1
2 **BEFORE THE STATE ENVIRONMENTAL COMMISSION**
3 **STATE OF NEVADA**

4
5 In Re:
6 Appeal of Air Operating Permit: Class I
7 Operating Permit No. AP4953-1148.01 by
8 Refuse, Inc.

**REFUSE, INC.'S OPENING
BRIEF**

13 Table 5.5-2 –Refuse, Inc. NO_x Increment Consumption

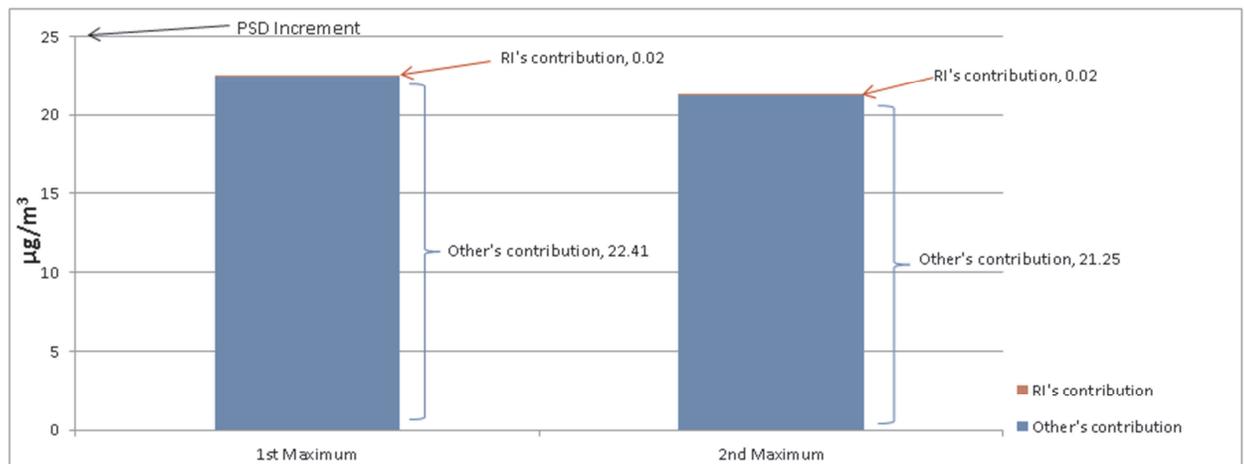
19 Table 5.5-2 shows no receptors where the concentration exceeds the increment standards for NO_x as the
 20 result of activities related to Refuse, Inc.'s Class I Significant Revision.

1 At the two receptors that have been identified by NDEP in the general vicinity of the
 2 Lockwood facility as having the highest PSD-increment consumption (22.43 $\mu\text{g}/\text{m}^3$ and 21.27
 3 $\mu\text{g}/\text{m}^3$, respectively),⁶ NDEP's analysis shows that RI's emissions contribute less than 1/10th of
 4 one percent of the total impacts (0.02 $\mu\text{g}/\text{m}^3$ in both instances). This is clearly trivial relative to
 5 the impact attributable to the other sources and the overall increment of 25 $\mu\text{g}/\text{m}^3$. The bar graph
 6 below shows the points of maximum increment consumption identified by NDEP's analysis and
 7 the contribution of the Lockwood facility to those impacts.

17 The contributions of RI's Lockwood landfill at both points of maximum predicted
 18 increment consumption are so small (0.02 $\mu\text{g}/\text{m}^3$) that they are barely visible as thin red slivers on
 19 the bar graph above, indicating that the Landfill is having a negligible impact on the increment.

20 NDEP's analysis further shows that at the two receptors that have been identified by
 21 NDEP as having the highest impacts from RI's facility, the total maximum predicted
 22 concentration (that is, RI's impacts plus all other increment-consuming sources) is 3.24 $\mu\text{g}/\text{m}^3$
 23 compared to an increment of 25 $\mu\text{g}/\text{m}^3$. This again demonstrates that the proposed Lockwood
 24 LFGTE project does not pose a threat to the NO_x increment. The bar graph below shows the
 25 points of RI's maximum impact along with other sources at those points relative to the increment
 26 of 25 $\mu\text{g}/\text{m}^3$.

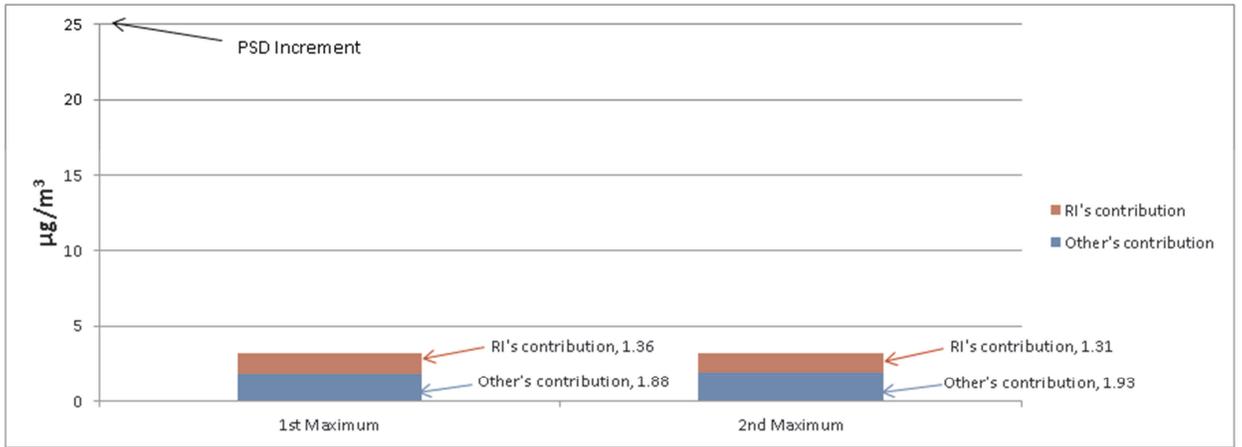
Accordingly, NDEP's own analysis contradicts its justification for requiring NO_x CEMS. Indeed, RI's emissions would have to be many times greater to have even a modest impact on the increment.⁷

**WMRE Cat 3520 Plants
NO_x Stack Test Results by Engine, lbs/hr**

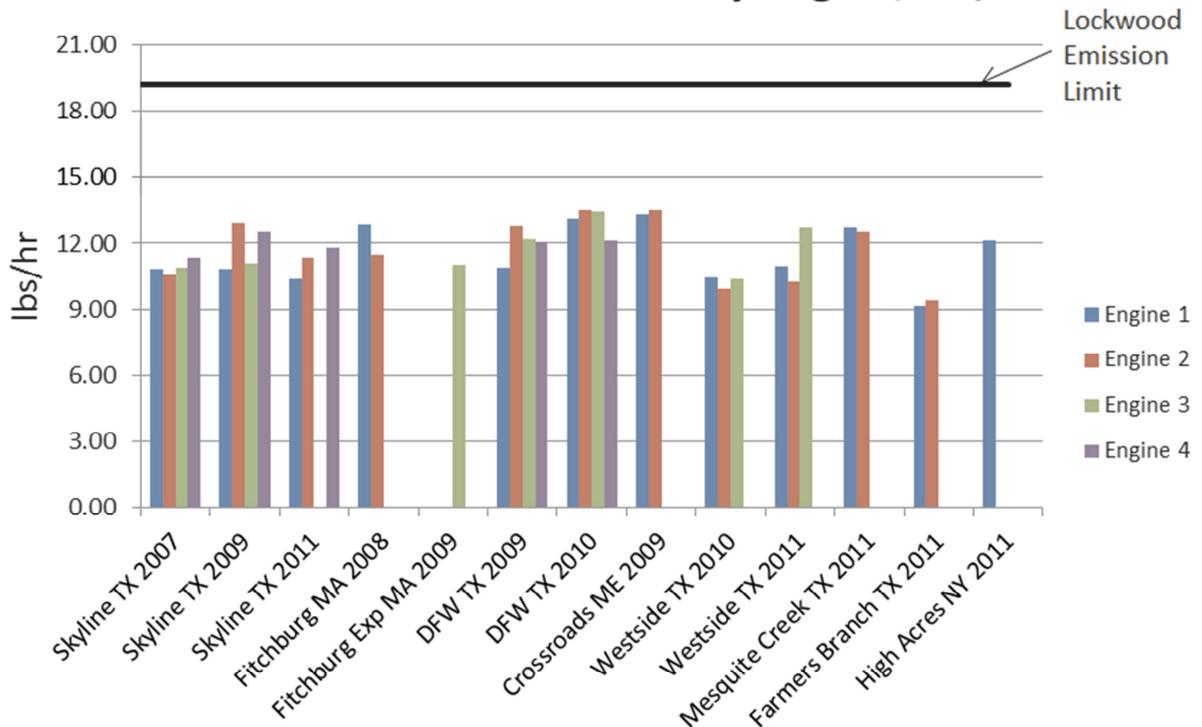
As this data demonstrates, without exception, the engines have demonstrated compliance with their NO_x and CO emission limits. Average NO_x emissions from the engines are 2.34 lb/hr (compared to an emission limit of 2.95 lb/hr) and average CO emissions are 11.63 lb/hr (compared to an emission limit of 19.2 lb/hr). The data supporting these summary tables is provided on the CD attached to this brief as Exhibit 5.
